MISSAN SURGICAL HOSPITAL
UNDER THE ECONOMIC SUPPORT FUND
AL AMARAH, IRAQ

SIGIR PA-08-165
SIGIR PA-08-167

Summary of Report: PA-08-165 and PA-08-167

Figure 6. Storm water pump station plan

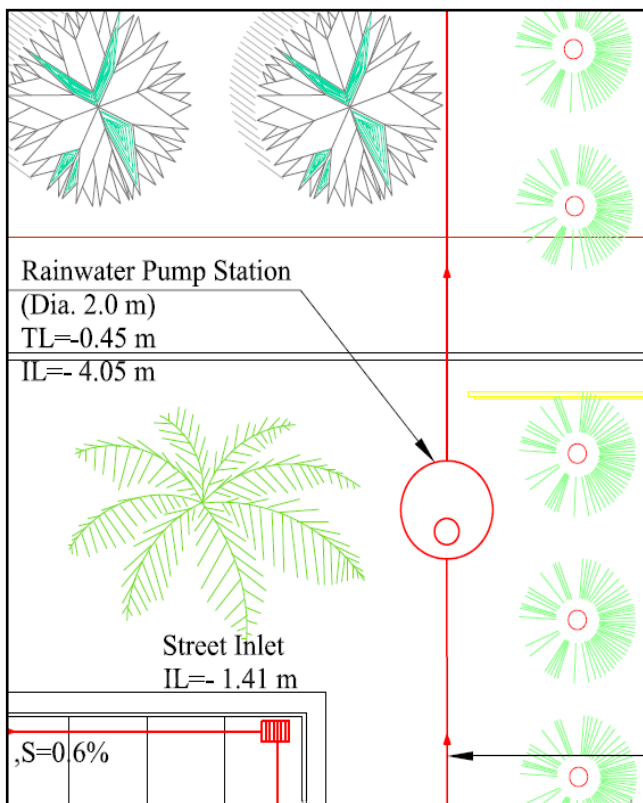
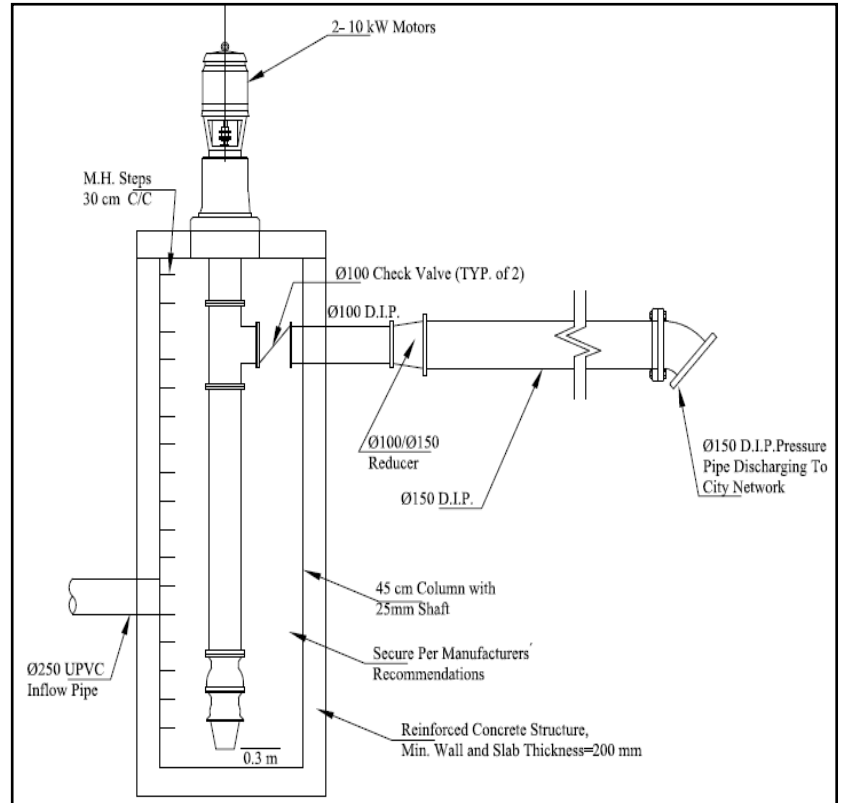
The contractor's plans lacked adequate information for SIGIR to determine how the pumps are controlled or how they will address low-flow conditions. SIGIR is concerned that the high capacity of the pumps combined with the small size of the wet well may result in a rapid cycling of the pumps leading to overheating and premature pump failure.

Figure 8. Perimeter retaining wall section

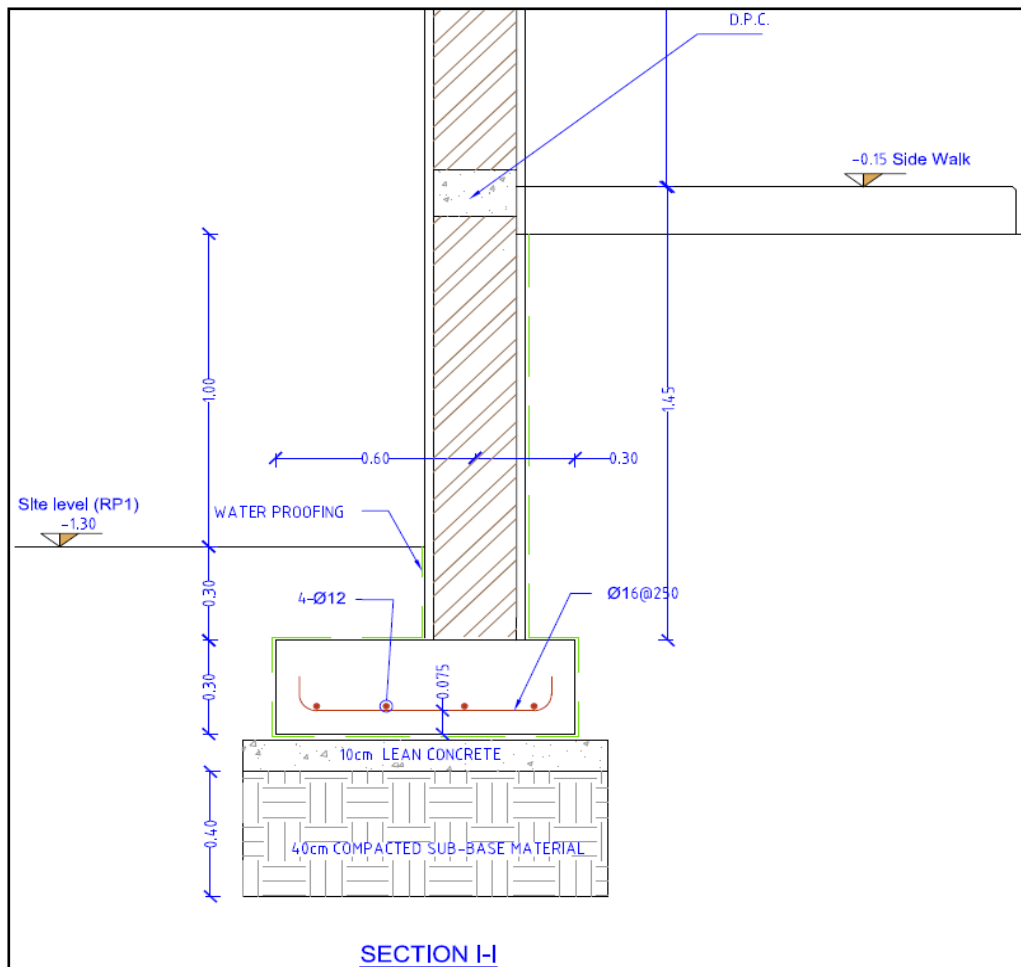
The contractor's design plan detailed the perimeter fence along the north edge of the project site. The plan indicated the application of waterproofing to the portion of the wall below grade (Figure 8). However, the application of waterproofing without the integration of subsurface drainage behind the wall may allow for the buildup of hydrostatic pressure against the wall and possible localized failure of the brick infill.

In addition, the external security fence design did not include any concertina or barbed wire at the top. With only two guard houses (one at each opening to the hospital) and a wall that is only 2m high, concertina wire maybe needed to better secure the facility.

Figure 9. Location of the two guard houses for the MSH (Courtesy of GRS)

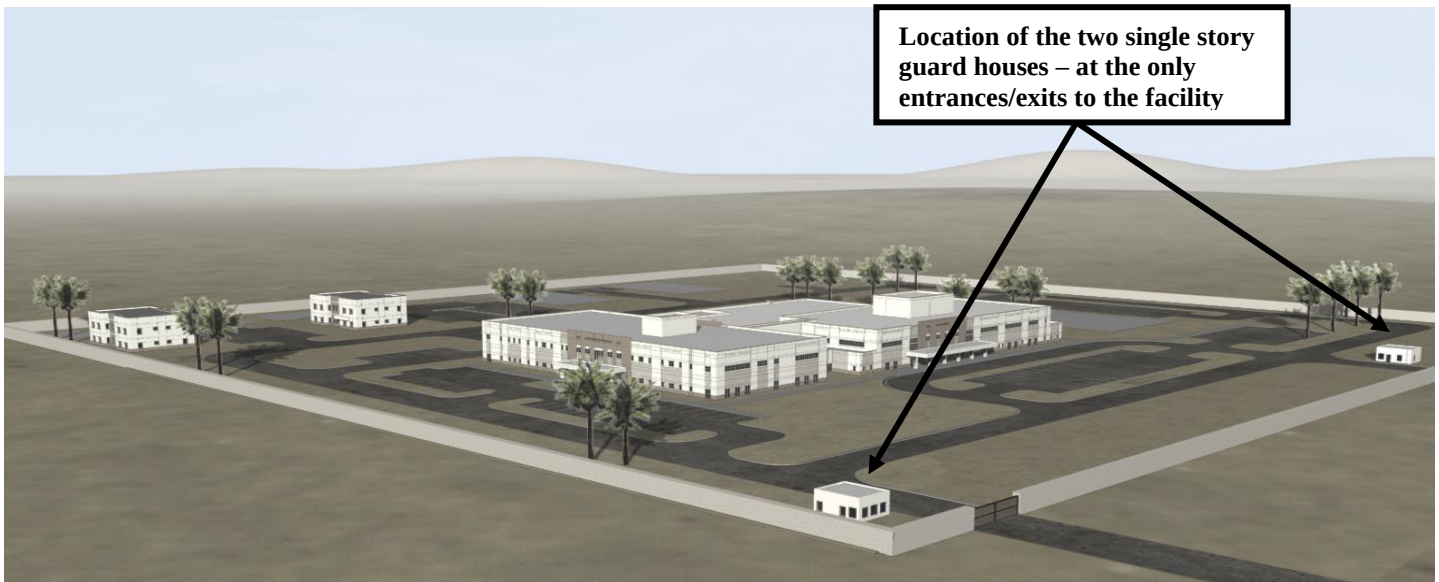
In addition, both the U.S. government and contractor's designs called for only two guard houses (one at each entrance/exit to the hospital – Figure 9). The single-story guard houses provide hospital security by checking people and vehicles as they enter the facility. However, since the guard towers are not elevated and the perimeter security wall is 2m high, the guards will have no ability to monitor any area of the facility outside of the entrances/exits. Consequently, this leaves the perimeter of the hospital site vulnerable to attack. Considering the overall size of the project site is 62,500 m² and the main hospital buildings obstruct a significant portion of the view

from the guard house, additional guard houses and elevated guard towers are necessary to provide adequate security.

Figure 10. Contractor’s river intake detail design (Courtesy of GRS)

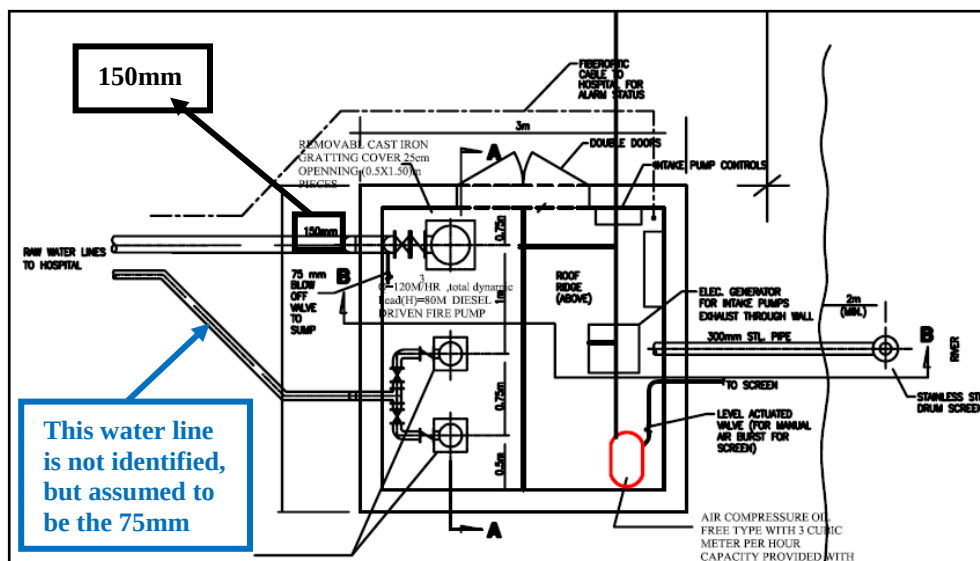
In addition, GRS provided two designs drawings for the raw water intake; both designs dated 30 April 2008. These designs, dated 8 months prior to SIGIR’s site visit, were not part of the original project file documentation provided to SIGIR; instead GRS provided these drawings after the exit conference. After reviewing both designs, SIGIR determined them to be, at best, conceptual designs because they lacked specific details on piping elevations and lengths, electrical systems designs, access roads, flooding levels, and grading requirements.

Further, when placed together, the two designs clearly show a lack of detail and cohesion. For example, the SOW required two water lines – one for water processing and one for fire suppression. The “River Intake 6-5 River Intake (1)” design identified only the 150 mm water line; while the “site-maissan Water(27) WATER FIRE(27)(1)” design only identified the 75 mm water line (Figures 10-12). Also, since the security wall has already been constructed, the contractor will now have to excavate under it in order to route the water lines under the wall. In addition, the exact location of the river intake has yet to be determined; instead GRS AAO stated it will be “located approximately where the Tigris [River] and Al Kahla [River] intersect.”

Of particular concern to SIGIR is the lack of the defined route from the river intake to the hospital. According to GRS, the current plan is to place the river intake near the intersection of the Tigris and Al Kahla Rivers and then run the water lines to the hospital site. However, this would require the contractor to excavate and lay two pipe lines a total of 3.1 km through a significant portion of the city of Al Amarah (Figure 13). In a previous SIGIR Inspections report of the Falluja Wastewater Treatment Plant, SIGIR documented significant delays and serious security issues due to the fact the contractor had to excavate and lay pipe through the city.

**Figure 13. Aerial view of the water lines to be run from the river intake to the hospital site
(Courtesy of the National Geospatial-Intelligence Agency)**

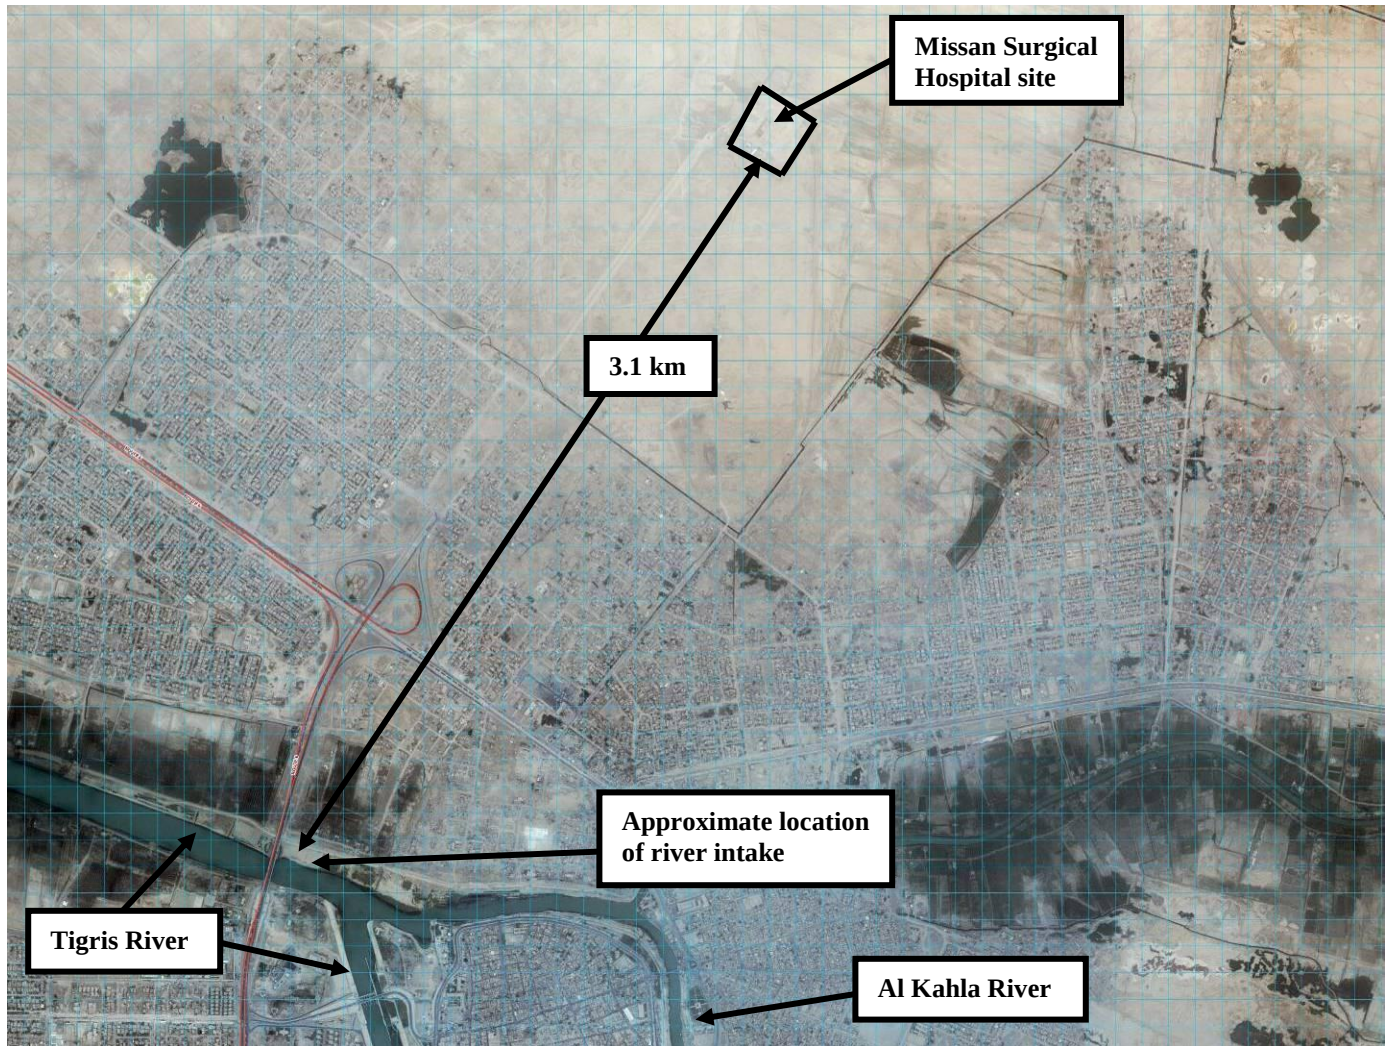
According to GRS AAO representatives, the contractor is currently “working with the municipality for routing the water lines.” However, SIGIR believes that the planning for the identification of the water source, location of the river intake, and routing of the water pipe lines to the project site needed to be done at the onset of the project, not 20 months after the NTP was issued. GRS, the contractor, and the municipality should have discussed the various options for the water supply at the beginning of the project. The delay in addressing this issue has resulted in the contractor and municipality having to determine the least intrusive method to install below ground water lines. As was learned from the Falluja Wastewater Treatment Plant inspection, excavating through a city is challenging and could be slow and dangerous work for the contractor.

In April 2009, SIGIR brought these deficiencies to GRS AAO’s attention. Specifically, the latest version of design drawings GRS provided SIGIR were not detailed, omitted significant information, and were not complete.

Figure 14. Contractor’s overall wastewater treatment plant schematic drawing (Courtesy of GRS)

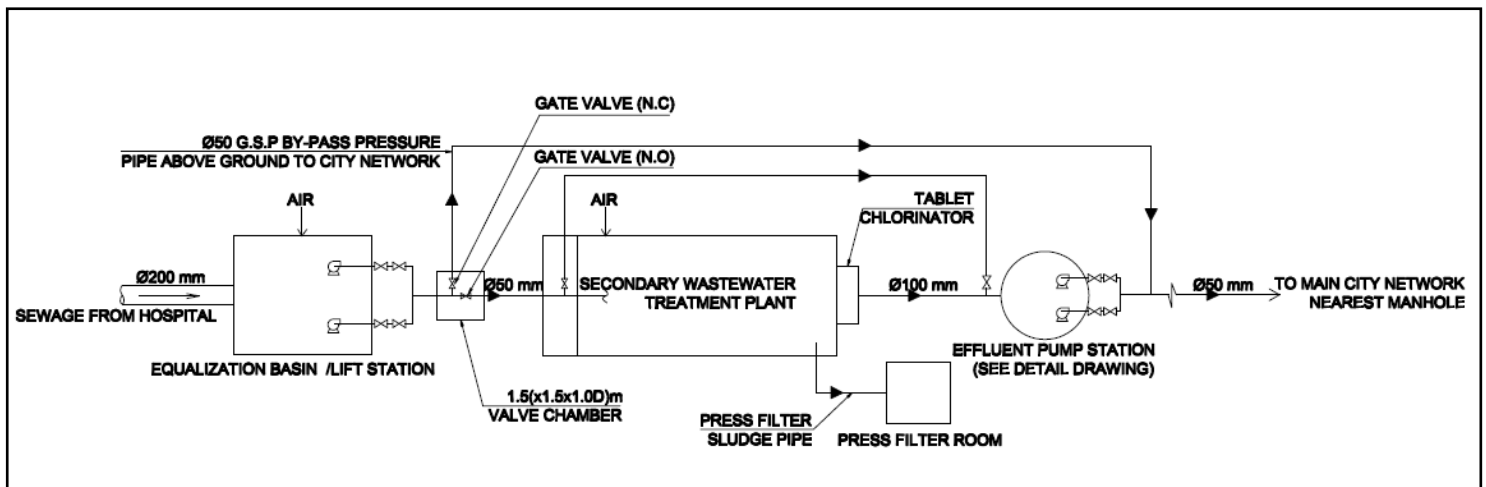
After thoroughly reviewing the sewage treatment plant designs, SIGIR noticed a lack of specific details in certain areas that may be problematic during construction and/or cause issues with long-term operations and maintenance (sustainment). Specifically, the following areas lacked specific design details that may negatively affect the performance of the facility:

- The press filter room is not detailed on the plans and the type and size of filter press equipment is not indicated. The press filter room is indicated on the architectural plans with an entry of 0.45 m (18 inches) above grade. It is unclear how the sludge cake will be removed from the filter press room or how large equipment maintenance will be performed.

- The valve chamber and bypass piping for the sewage treatment plant is not detailed. Proper planning of the valve chamber and piping is essential to preclude piping conflicts and field modifications during construction.

- Float levels or alternate controls for submersible pumps are not shown. These levels should be calculated in conjunction with wet-well sizing calculations. Improperly sized wet-wells and/or improperly set pump controls may result in rapid cycling of the pumps leading to overheating and premature pump failure. Conversely, extended storage times may create septic conditions resulting in offensive odor and difficulty in treatment.

Similar to the water supply system, the wastewater system design lacked significant details, such as the alignment and outfall of the sewage leaving the hospital site. Figure 14 shows the overall wastewater treatment plant schematic drawing, which indicates that the sewage leaving the hospital will be deposited directly into the “main city network nearest manhole” without identifying the exact location and distance to the nearest manhole, the size, elevation, and condition of the main city network sewer pipe, and whether or not an analysis has been performed to determine if the existing city network system can accommodate the significant additional flow the hospital will provide. To ensure that sewage does not back up into the hospital or in nearby neighborhoods, it is important that the network have the capacity to handle the additional flow.

Figures 15 and 16. The contrast between the 80% design single column configuration (left) and the contractor's triple column configuration (right). The triple column configuration is less efficient space wise and less aesthetically pleasing. (Courtesy of GRS)

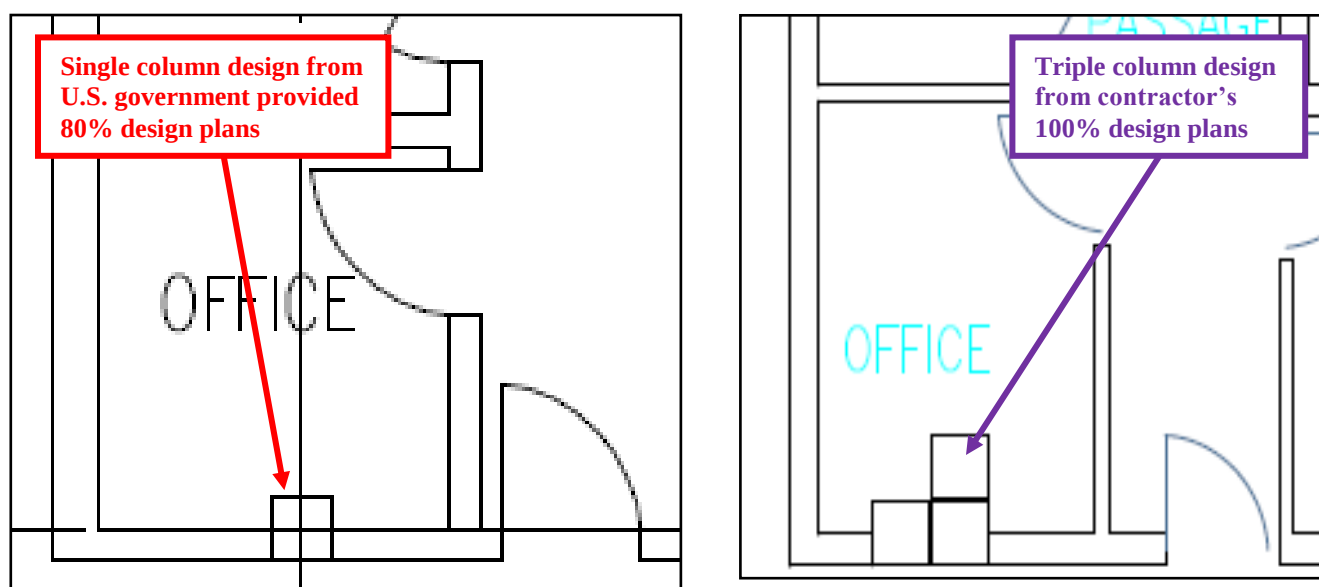
The design drawings include a structure layout with additional columns to accommodate expansion joints in the building. While the floor plans were adjusted to accommodate the additional columns, there appeared to be spatial conflicts in several of the rooms. For example, Figure 15 is the original floor plan (80% design), which allocated a 0.5 m x 0.5 m column in this office; while Figure 16 is the contractor's re-design, which added the expansion joint and two additional 0.5 m x 0.5 m columns for the same office. Although the contractor made the office larger to compensate for the undesirable use of space, the additional columns render the office less efficient and aesthetic than if the floor plan was modified to place the columns in less obtrusive locations. SIGIR observed this in several locations.

Site Photo 3. Perimeter security wall construction

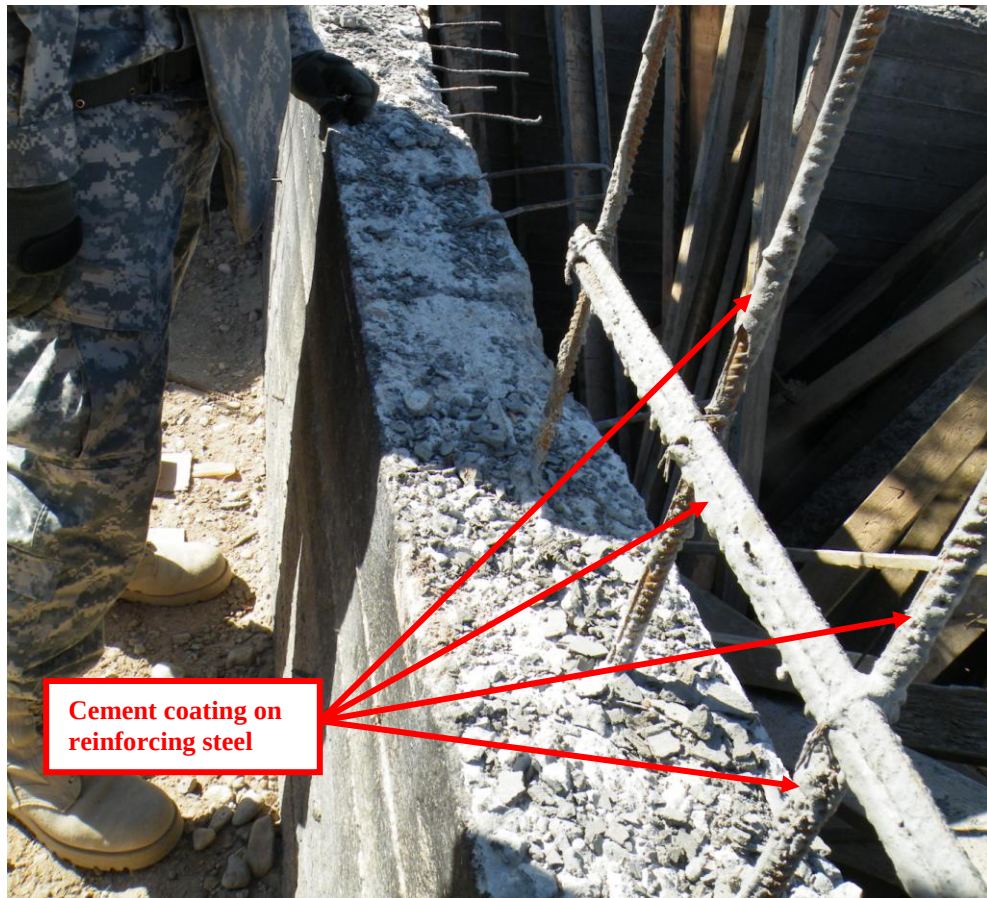
The security wall appeared to be poorly constructed. For instance, the contractor did not properly construct the haunches for the reinforced concrete beams along the top of the wall. Since the wall beams do not function as significant load bearing members, this is mostly a cosmetic issue, however, the inability of the contractor to construct this connection on this relatively simple part of the project calls into question his ability to adequately construct the considerably more difficult beam-column connections for the main hospital structure. Failure to construct adequate beam-column connections for the primary structural members of the hospital may compromise the lateral stability of the structure. Lack of lateral stability increases the likelihood of structural failure and/or collapse under seismic or wind loading. In addition, a gap existed between the last row of bricks and the concrete beam, which had to be filled with raw materials found on site. Further, the contractor left pieces of wooden formwork in the wall, which not only demonstrates poor practices by the contractor, but more importantly over time the wooden pieces will rot and could adversely affect the integrity of the wall.

the wall, there will be a buildup of hydrostatic pressure against the wall. A buildup of hydrostatic pressure, over time, could result in a reduction of the wall's strength, leading to eventual failure.

At the time of the site visit, the perimeter wall appeared adequate as a deterrent to anyone attempting to unlawfully enter the compound; however, the concerns identified by SIGIR regarding the wall's construction will ultimately affect the wall's long term sustainability.

Figure 17. Comparison of typical design column section versus column as constructed

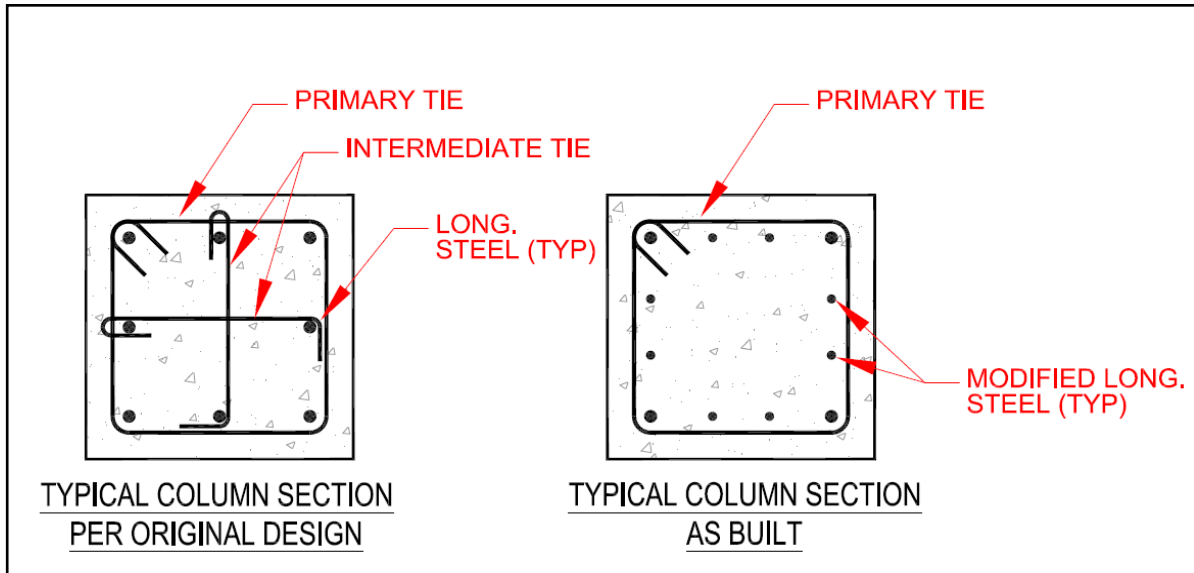
In addition, SIGIR noted that the reinforcing configuration used in the construction of the reinforced concrete columns varied from the configuration specified in the design drawings. Figure 17 clearly illustrates the difference between the design drawing and actual construction of the reinforcing configuration. The design drawing required three separate pieces of reinforcement bar along with two ties (primary and intermediate). The primary ties a steel bar around the perimeter of the vertical reinforcement bars; while the intermediate ties a steel bar from the middle reinforcement bar of one side to the other. However, the contractor opted to use four vertical pieces of reinforcement bar along with a primary tie around the perimeter.

In order to more clearly illustrate the difference in the design versus actual construction, Figure 17 is the reinforcement configuration from the design drawings; while Figure 17 and Site Photo 5 document the actual construction performed by the contractor.

After reviewing the design drawings, it appeared the contractor referenced the Iraqi Building Code Requirements for Reinforced Concrete (IBCRRC). Specifically, IBCRRC, section 10.6.5.3 states:

“Ties shall be arranged such that every corner and alternate longitudinal bar shall have lateral support provided by one corner of a tie with an included angle of not more than 135 degree and no bar shall be farther apart than 150 mm clear on each side along the tie from such a laterally supported bar. Where longitudinal bars are located around the perimeter of a circle, a complete circular tie may be used.”
